SUBJECT: CURRENT BACKFIT PRACTICES

SUBJECT: Beaver Valley Power Station - Unit No. 2
Docket No. 50-412
Identification of Backfit Requirement Number 1

SUBJECT: Beaver Valley Power Station - Unit No. 2
Docket No. 50-412
Identification of Backfit Requirement Number 17

FIG. RESPONSE 8.12(2)-3
AIR STARTING SYSTEM
BEAVER VALLEY POWER STATION-UNIT 2
PRELIMINARY SAFETY ANALYSIS REPORT

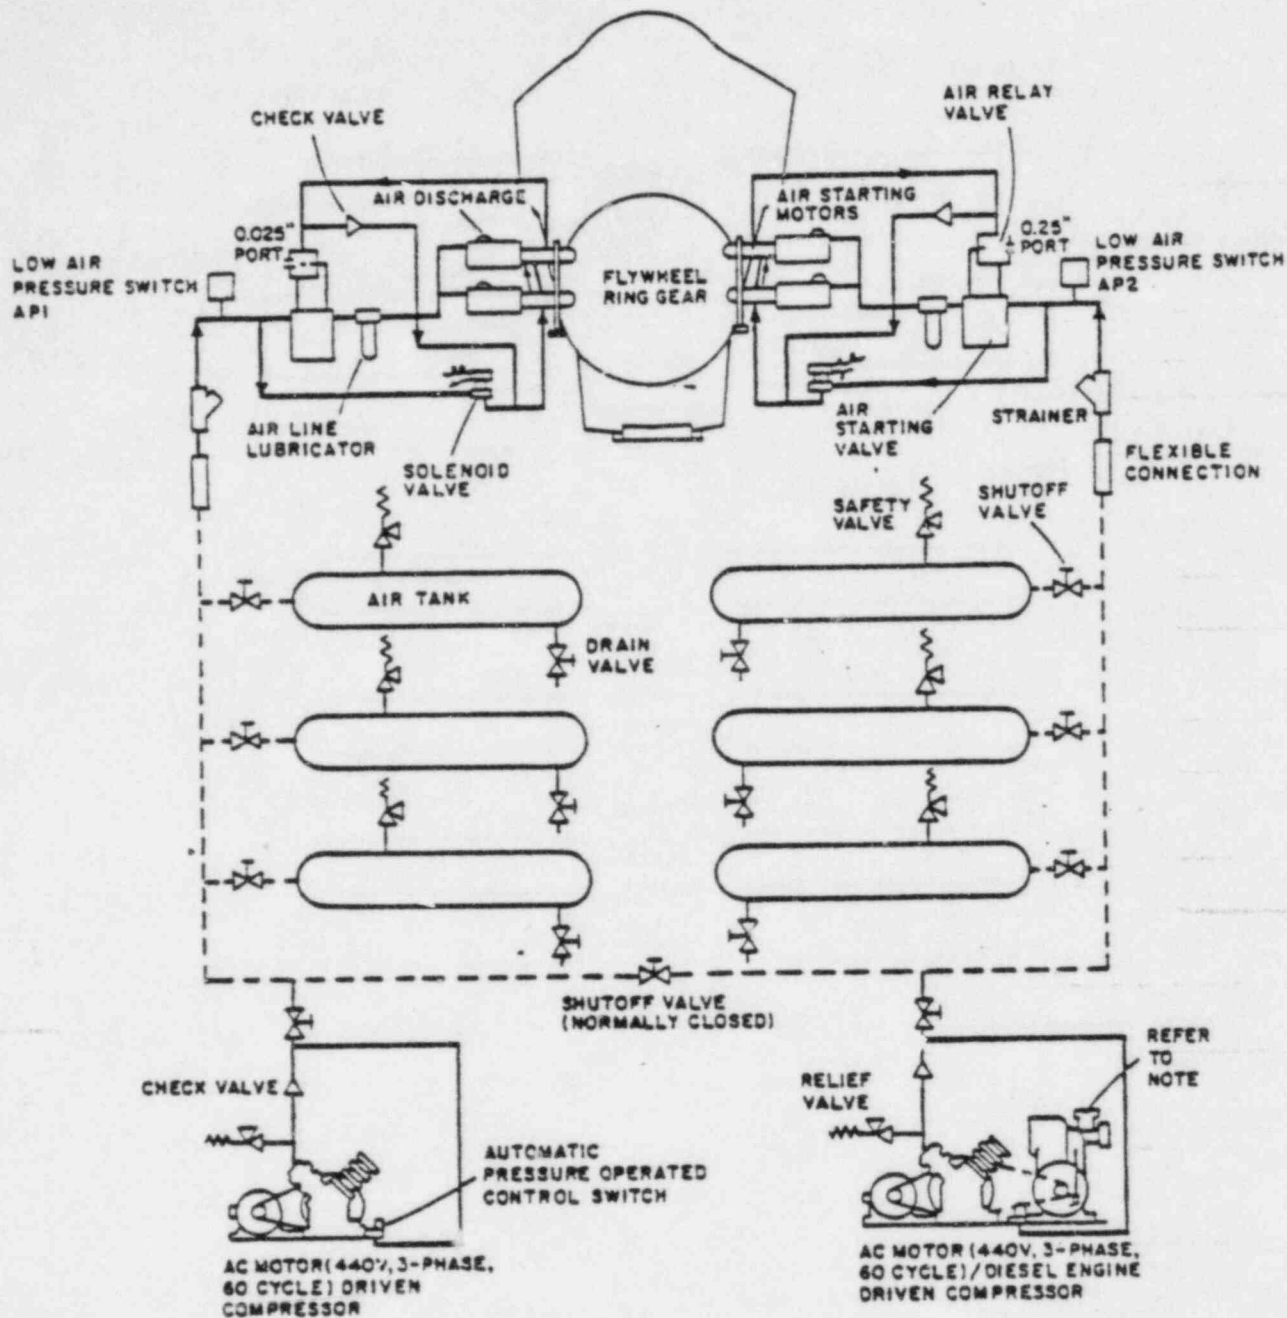
On September 19, 1983, the NRC staff issued questions 430.97 and 430.100 (Attachment 3). Question 430.100 states, "... we require that compressed air starting system designs include air dryers for the removal of entrained moisture." In this question, the NRC staff directs, "Revise your design of the diesel engine air starting system accordingly" Attachment 3 (originally Attachment 3 to DLC letter 2NRC-4-032, dated March 28, 1984) also includes the DLC responses to questions 430.97 and 430.100. In these responses DLC has appropriately addressed the technical aspects of the question. A draft copy of this response had previously been provided to the staff reviewer. In a telephone conference with DLC (February 22, 1984), the staff reviewer indicated that his concerns were not satisfied and that air dryers would be required. He cited NUREG/CR 0660, "Enhancement of On-site Emergency Diesel Generator Reliability" (the University of Dayton study referenced in question 430.100) as his basis for requiring that DLC install air dryers.

Revise your design of the diesel engine air starting system accordingly, describe this feature of your design. Also expand your FSAR to discuss the procedures that will be followed to ensure the dryers are working properly and the frequency of checking/testing (SRP 9.5.6, Parts II and III).

The requirement to change the system design, after the initial design was approved at the issuance of the CP is a "backfit" as identified in 10CFR50.109. The change in the implementation of the SRP review procedure represents a new position on requirements and is identified as a "backfit" in Generic Letter 84-08 and the implementing NRC procedures.
